MC68341

ADDENDUM TO MC68341 Integrated Processor User's Manual

April 19, 1995

Figure 3-12. M68300 Write Cycle timing

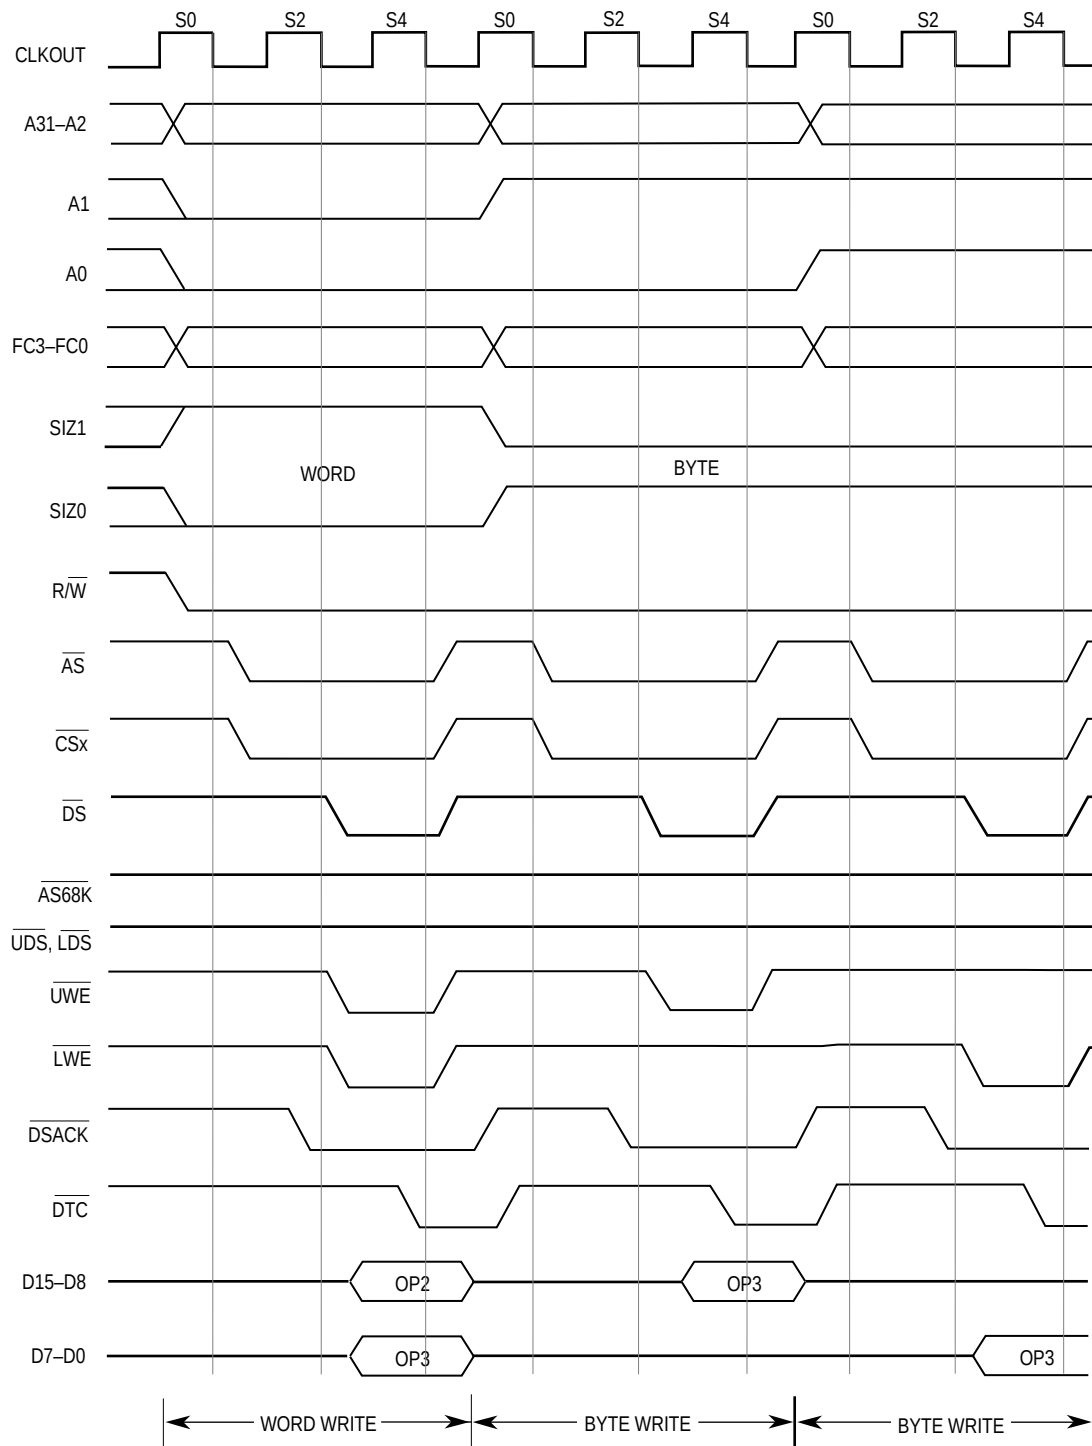
On page 3-25, the M68300 write cycle timing diagram (Figure 3-12) shows incorrect timing for $\overline{DS}$, $\overline{UWE}$, and $\overline{LWE}$. On page 3-28, the M68000 write cycle timing diagram (Figure 3-14) shows incorrect timing for $\overline{AS68K}$, $\overline{CSx}$, $\overline{UDS/LDS}$, and $\overline{UWE/LWE}$. Replace these figures with the following corrected figures.

Figure 11-2. Sample Crystal Circuit

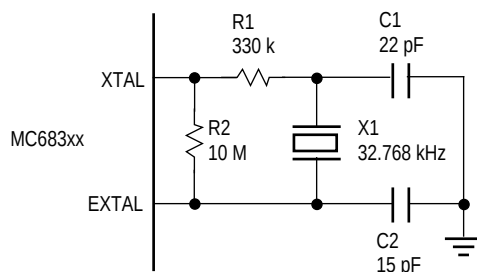
On page 11-2, Figure 11-2, a 10M resistor can be substituted for the 20M R2 bias resistor as shown below.

Figure 11-14. Circuit For Interfacing 8-Bit Device to 16-Bit Memory in Single-Address DMA Mode

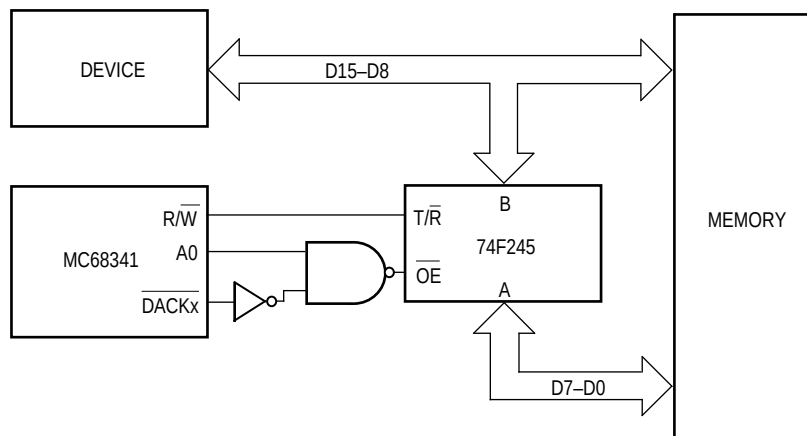
On page 11-10, the logic driving $\overline{OE}$ on the 74F245 in Figure 11-14 should be corrected as shown below. Although not detailed, the byte enables for the memory block should be controlled during reads to prevent contention between the upper and lower bytes of the data bus when D7-D0 is muxed to the upper data byte.

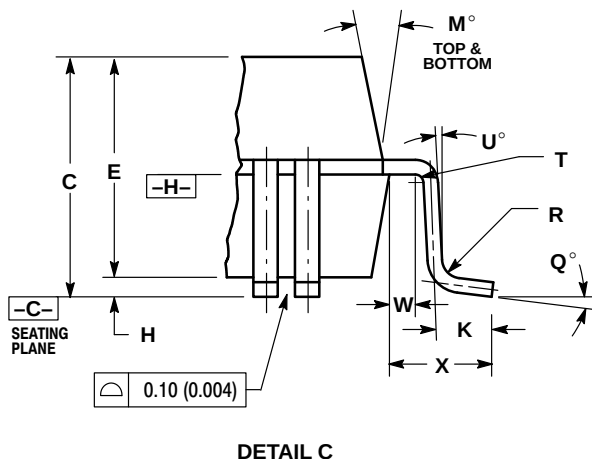
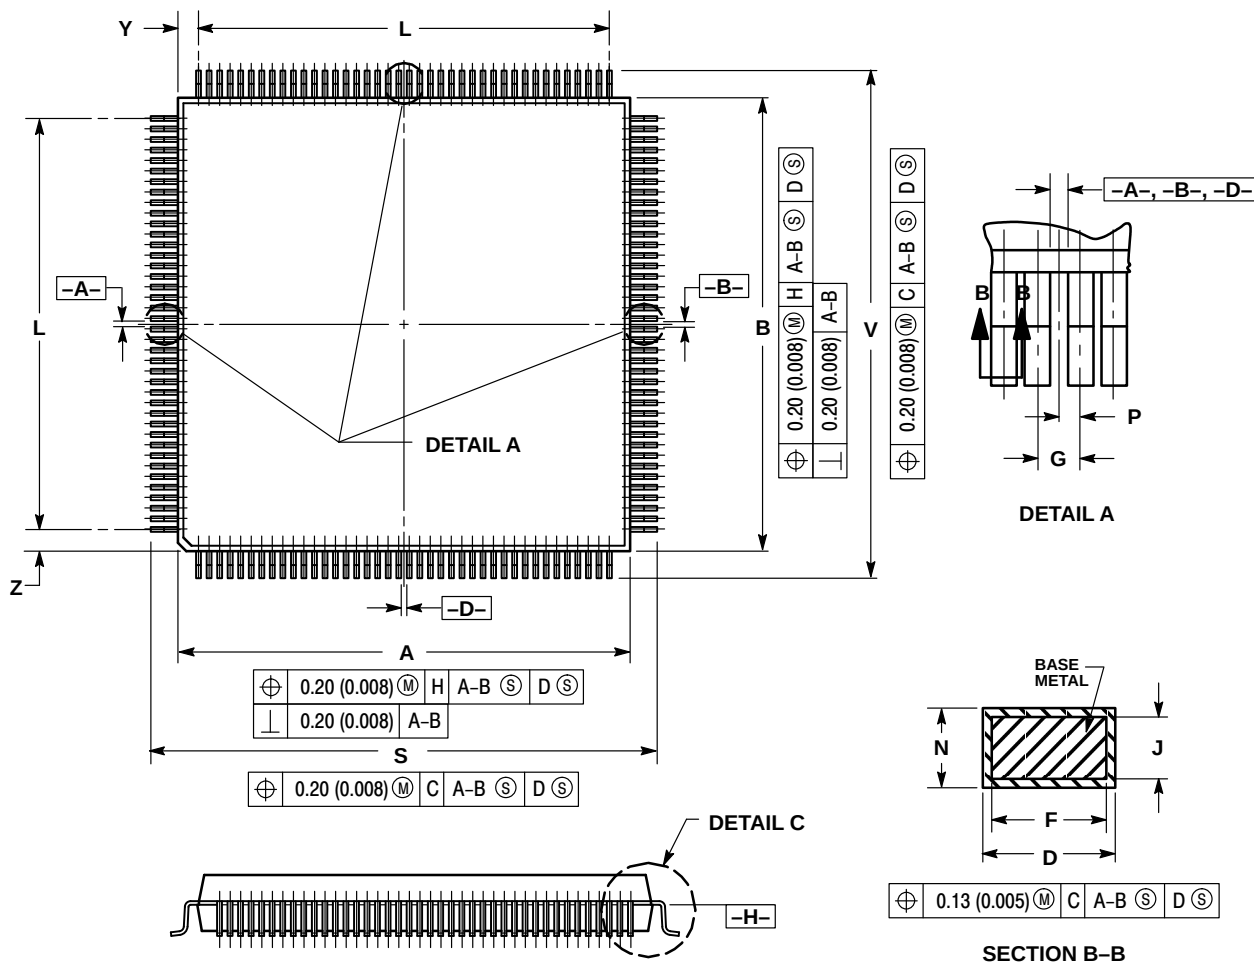
The package dimension drawing on page 13-3 should be discarded and replaced with the following drawing.
